- Tree Protection Plan-

WATTS PRD

Memo

To: Edie Berghoff, City of Poulsbo Associate Planner
From: Kevin M. McFarland, City of Poulsbo Contracted Arborist
Date: 2/28/23
Re: The Plateau at Liberty Bay Proposed Tree Retention Review

Attachment 2. Watts Subdivision Site Plan

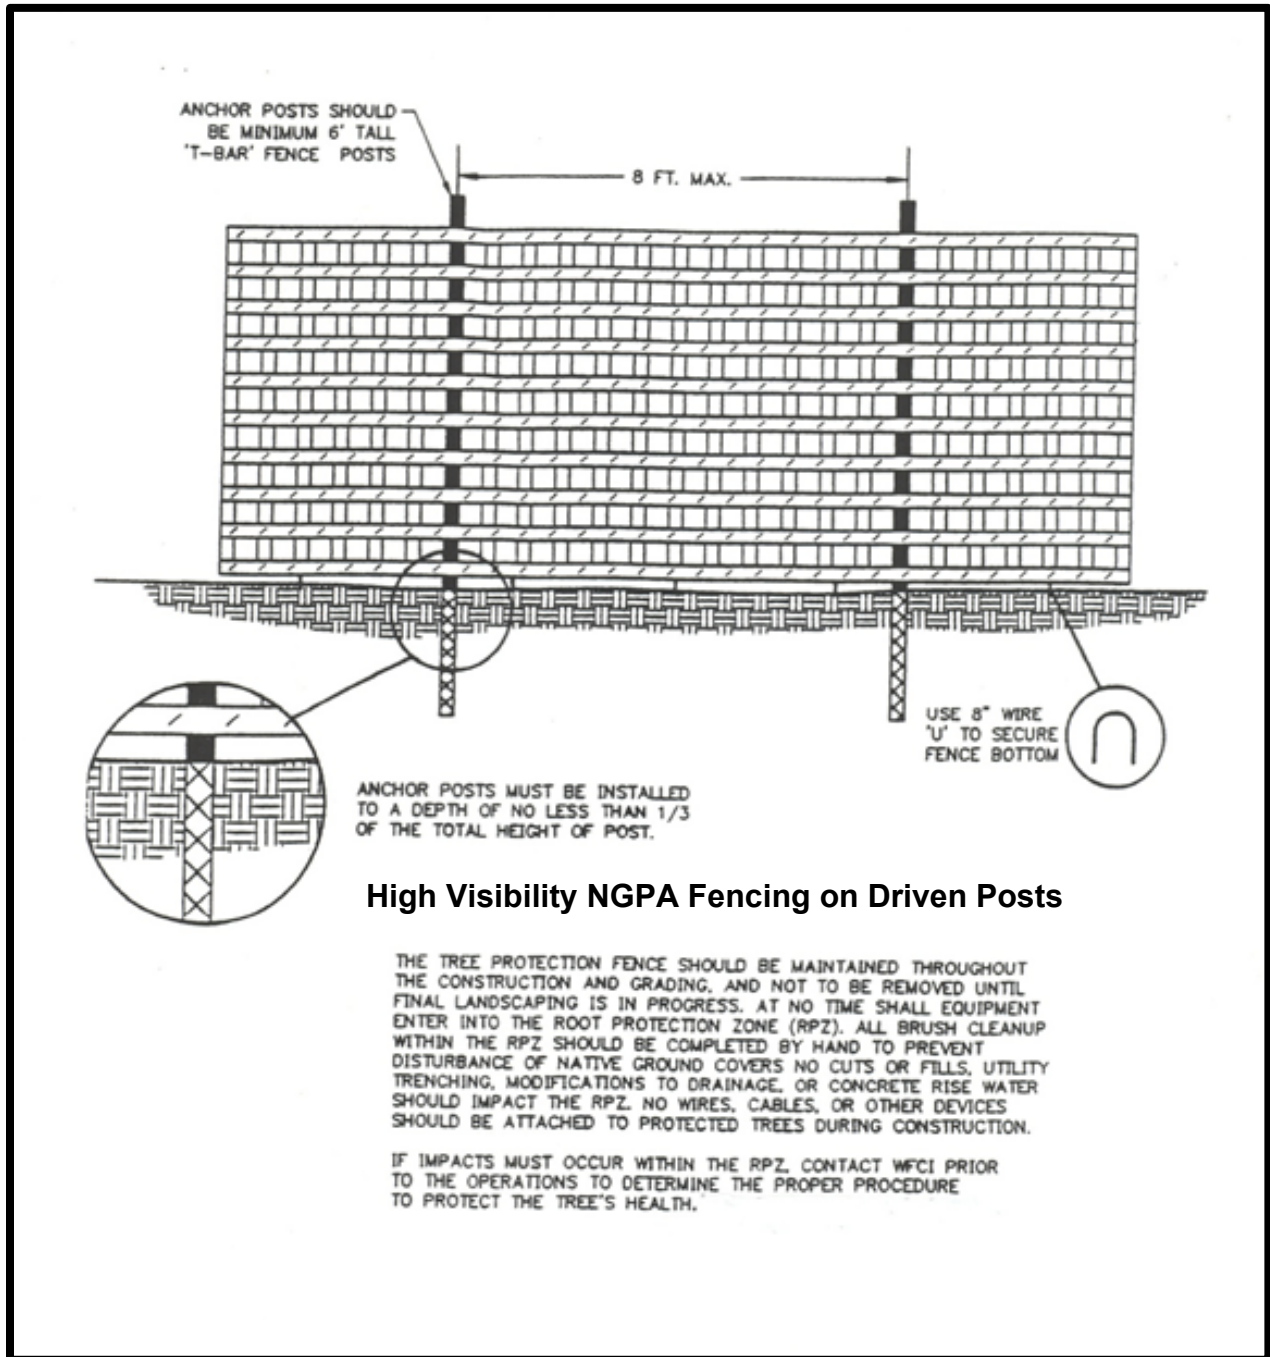
The tree protection measures and timeline for activity as presented on pages 9 & 10 of the report should be included in the notes on the TESC and landscape plans. All tree protection fencing locations and the fencing diagram should be included as well.
